Review of Environmental Factors Addendum

Wollongong WRRF – changes to 3 upgrade projects

Figure 1 Proposal change and environmental constraints

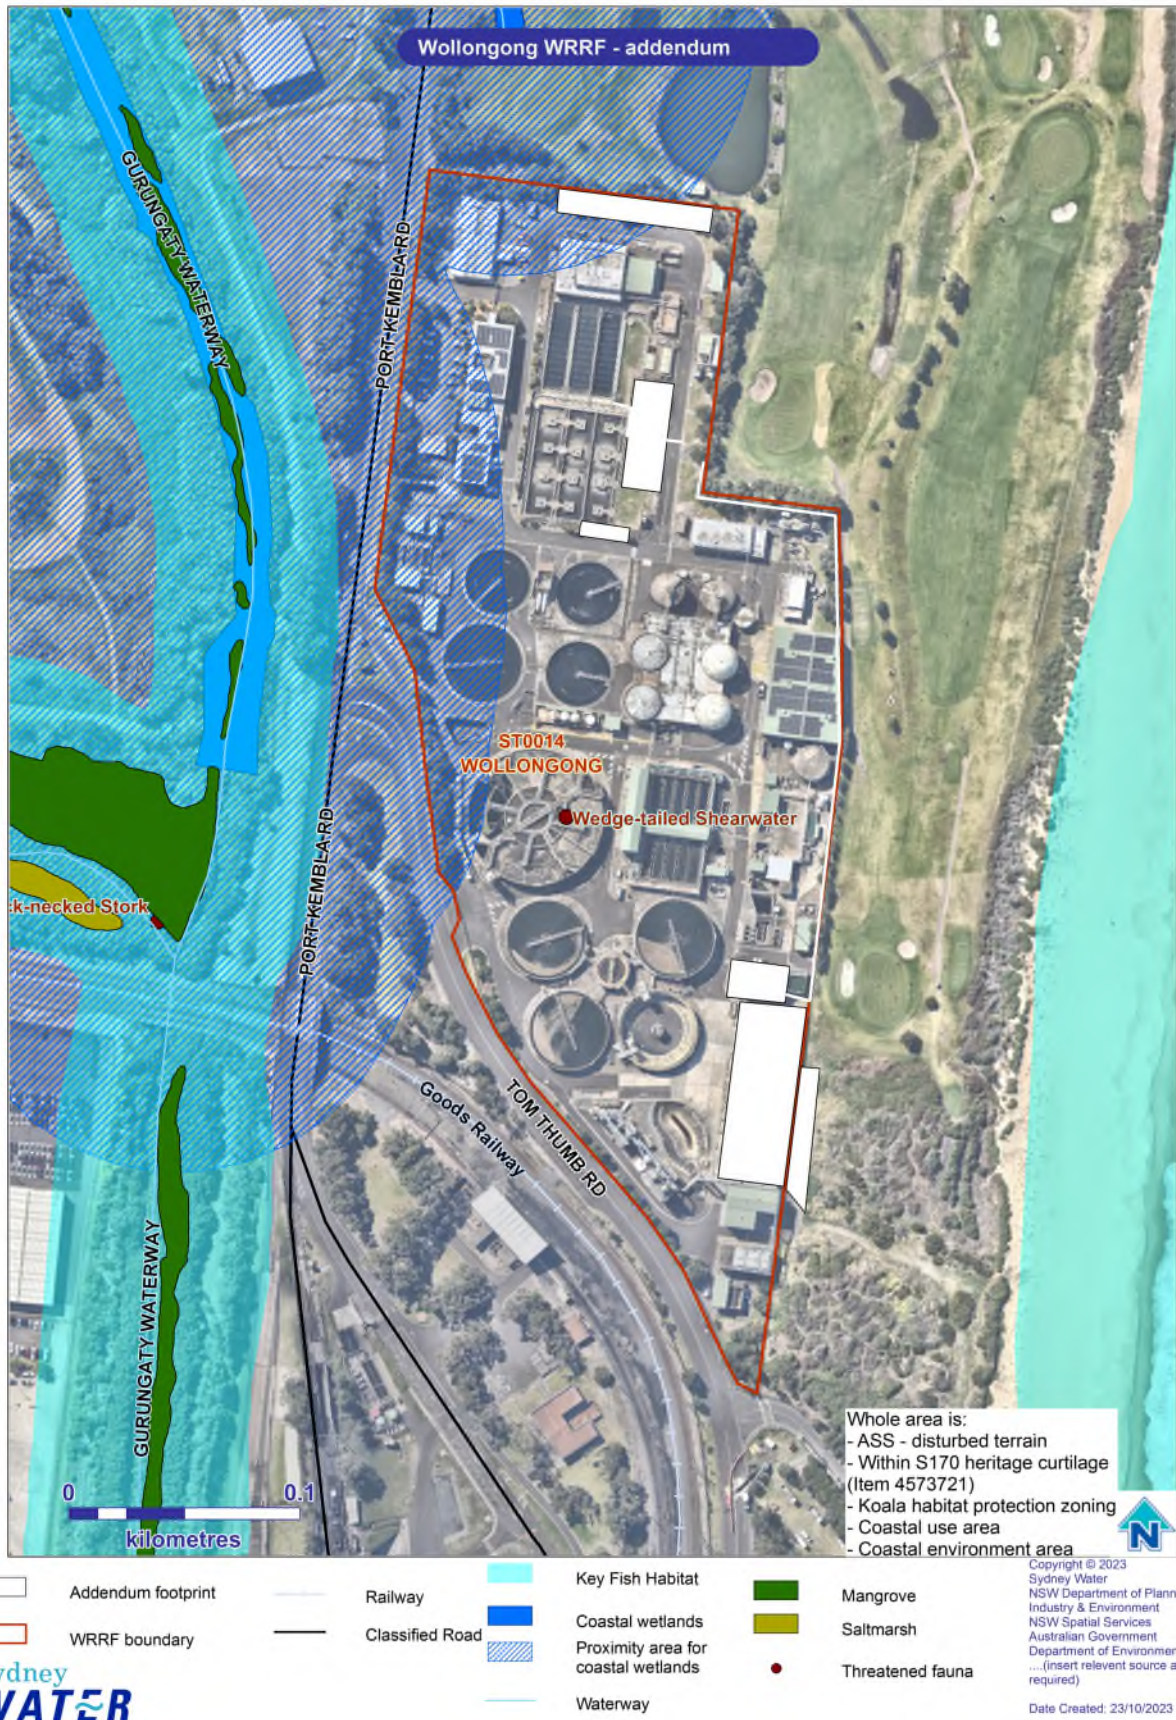
Project name	Proposed change	Justification
Biosolids Dewatering Upgrade REF (February 2019)	<ul style="list-style-type: none"> • Demolish sludge dewatering building. • Refurbish sludge hoppers, including the replacement of the levelling screw, bottom feed screw, and cells. • Remove roof, and supports of the biosolids out-loading building, for works on the sludge hoppers. This will be completed using a crane located outside of the plant boundary, positioned on an existing bitumen paved area. This area may need to be expanded to allow the works to be undertaken, and therefore require some trimming or clearing of vegetation. • Install new concrete slab for Rotary Drum Thickener (RDT), pipe supports, and pipe run, in the location of the old dewatering building. 	The dewatering building is currently unused and was decommissioned in 2006. Dewatering equipment required for the upgrades will not fit within the old building as there is insufficient space. Therefore, demolition is required so that the equipment can be stored in the same location on a concrete slab instead.

Inlet Works and OCF Upgrade REF (December 2020)	<ul style="list-style-type: none"> • Install a new tertiary effluent line to connect new OCU with effluent processing areas (already assessed in approved REF). <ul style="list-style-type: none"> ○ Additional impact: This will require clearing of vegetation along the eastern boundary, 	The new effluent line is a necessary connection to supply water to the new OCU, and vegetation

Project name	Proposed change	Justification
	<p>possibly involving removal of whole trees where they are directly next to the fence.</p> <ul style="list-style-type: none"> • Perform concrete repair and rectification work on 2 tanks and 2 gravity thickeners. • Install a cross-site pipe run from the grit classifiers and RE tank to the inlet works including minor excavation works for the plinths and brackets. 	<p>removal cannot be completely avoided.</p> <p>The other works are necessary maintenance activities, or connections between 2 assets required for the upgrades.</p>
<p>Inlet Screens Upgrade REF (February 2023)</p>	<ul style="list-style-type: none"> • Shift the location of new wet well and pumps north of the area identified in the approved REF. • Perform associated vegetation removal inside the fence on the northern boundary of the plant. 	<p>This change is required as a result of there being insufficient space adjacent to the existing inlet building, and proximity to existing structures (as proposed in the approved REF) making the deep excavation for the new wet well and pumps challenging.</p>

Figure 2 Approximate construction footprint of approved REFs and addendum

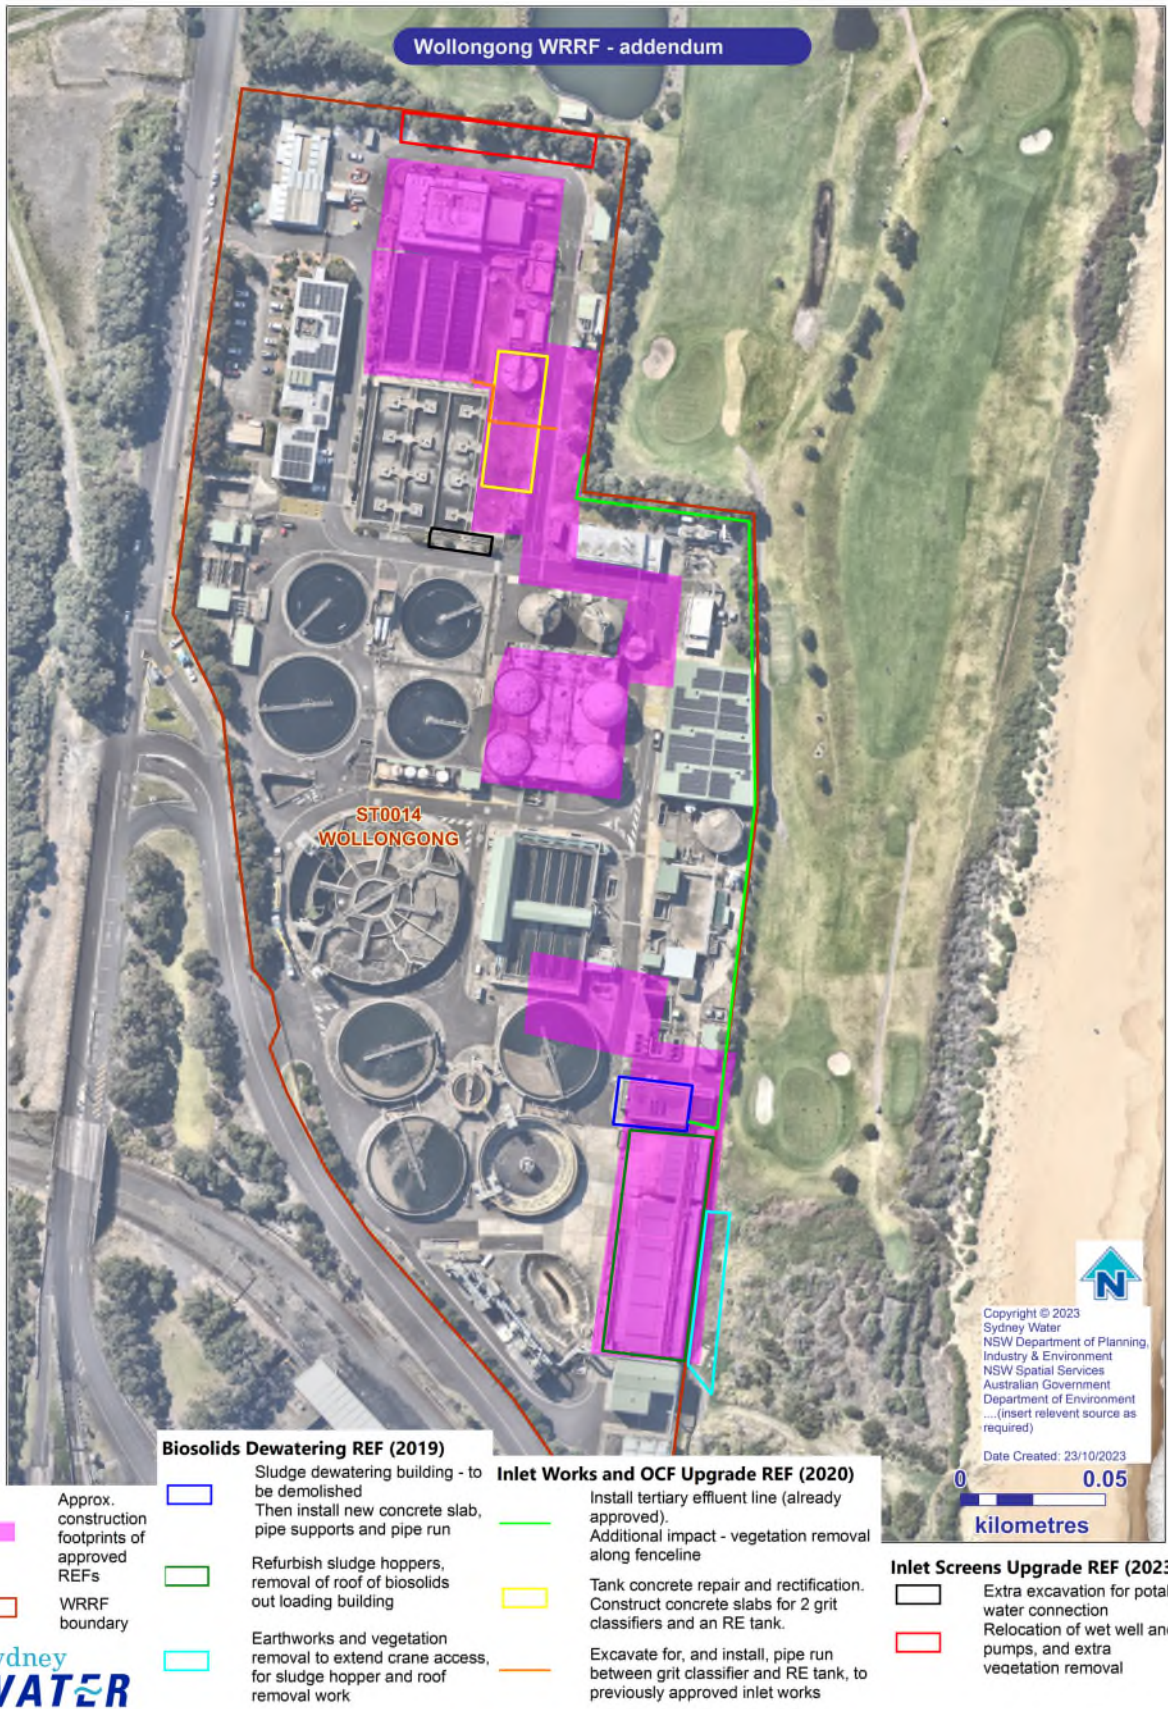
- installing effluent line inside eastern fenceline (about 300m length) – refer green line on Figure 2. Impacts required to managed exotic grasslands and landscaped areas. Clearing of vegetation along the fenceline is required where the vegetation overlaps with the alignment of the effluent line. For vegetation near the effluent line but away from the fenceline, trimming is preferred.

- relocating wet well and pumps (about 700m²) – refer red box on Figure 2. Impacts required to landscaped edges with planted trees and shrubs. Most of this vegetation will require removal, due to the deep excavation for the wet wells and pumps.

- earthworks to extend crane access (about 500m² total – although this area is not fully vegetated) – refer light blue box on Figure 2. Impacts required to exotic dominated shrub. Clearing within this footprint is required, however since the vegetation is mostly shrubs, minimal mature vegetation removal is required.

Figure 1 – Overall Scope of Proposed Inlet Works Upgrade

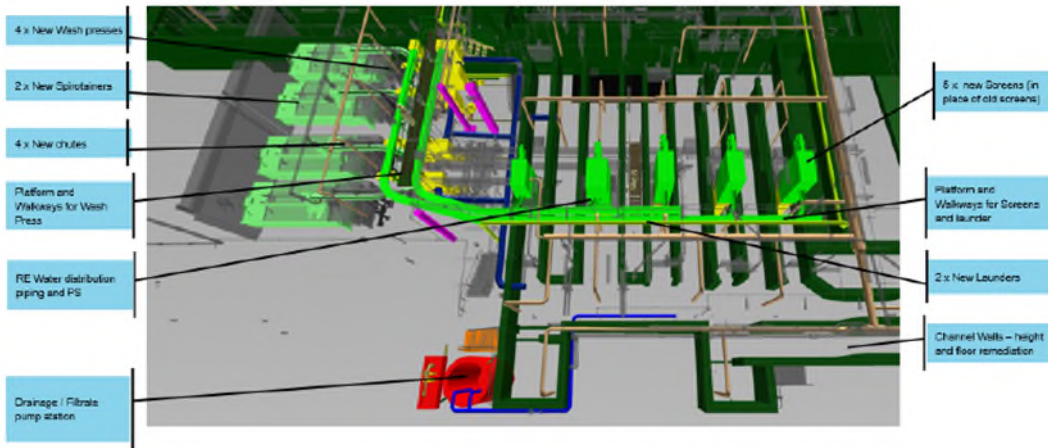
- Replacing the five existing step screens, with five centre flow band screens to deal with assessed capacity
- Replace screenings screw conveyors with two sluice launders as method of screenings transfer

- Modify existing inlet works building to accommodate 4x wash presses and spirotainers
- Replace existing washpresses with four new washpresses to provide enough capacity for hydraulic and solids loads, supply two additional screening spirotainers and replace screw conveyors with two sluice launders

- Balance airflow between grit tanks with installation of flow meter(s) and automatic control valves
- Replace two grit vortex washers, two grit transfer pumps and relocate grit vortex washers
